Submission of Further Information (FI)

**Proposed Temporary Private Vehicle Park (Private Cars Only)
for a Period of 3 Years in "Village Type Development" Zone,
Lot 343 (Part) in D.D. 113, Kam Tin, Yuen Long, New Territories
(Application No. A/YL-KTS/1090)**

Further Information for Planning Application No. A/YL-KTS/1090**Response-to-Comments****Comments from the Drainage Services Department**

1:500 (A3)	Drainage Proposal Lot 343(Part) in D.D. 113	Goldrich Planners & Surveyors Ltd.
November 2025		Plan 5.1a (P 25040)

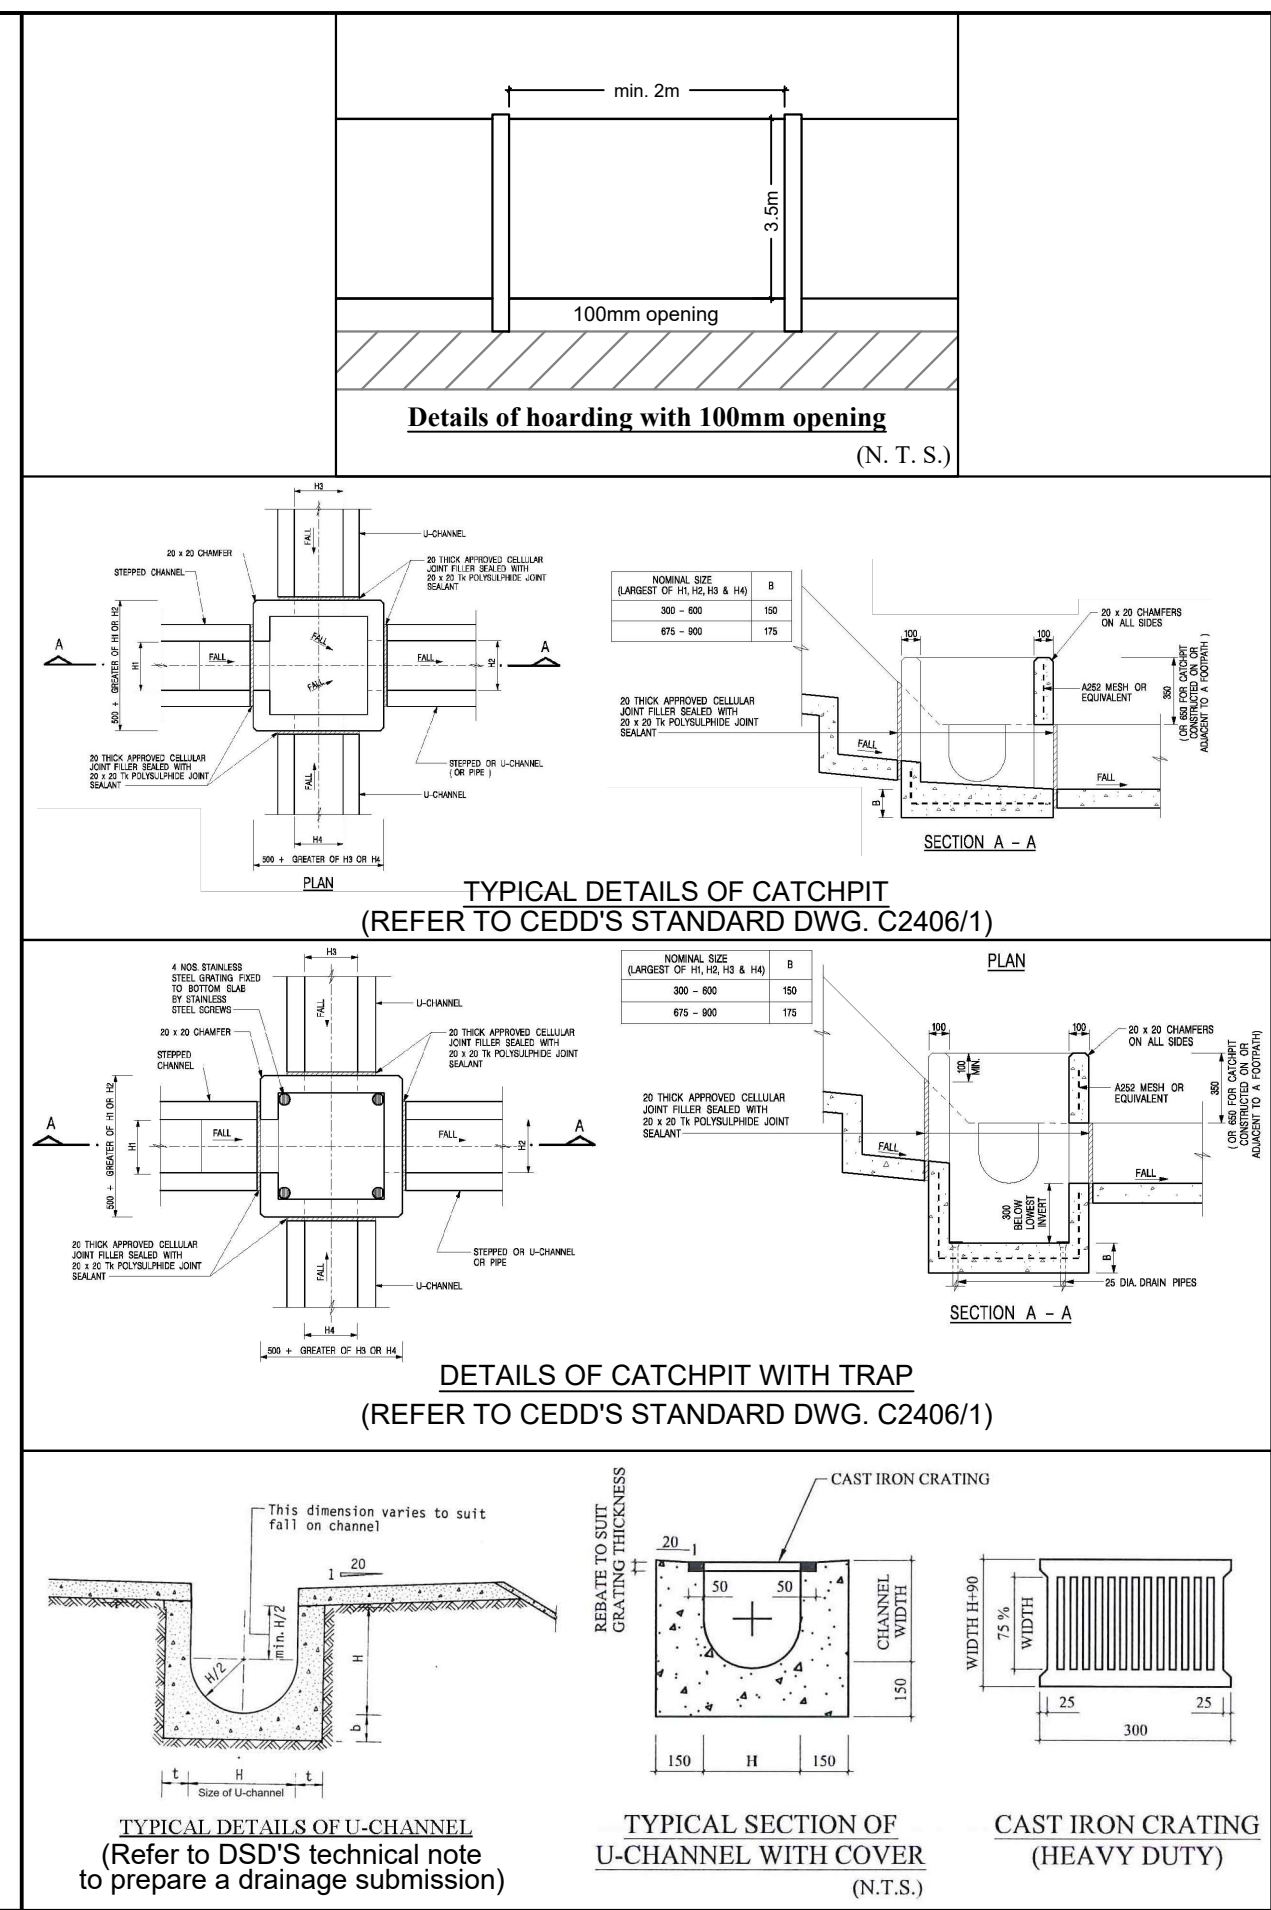
4.	Colour photos to indicate the current conditions of the existing drainage facilities i.e. the existing 350UC should be included in the submission. The photos taken locations and angles should be shown on the layout plan.	We revisited the site. The width of the existing drainage facilities is updated. Please refer to Plan 5.1a and viewpoint photos.
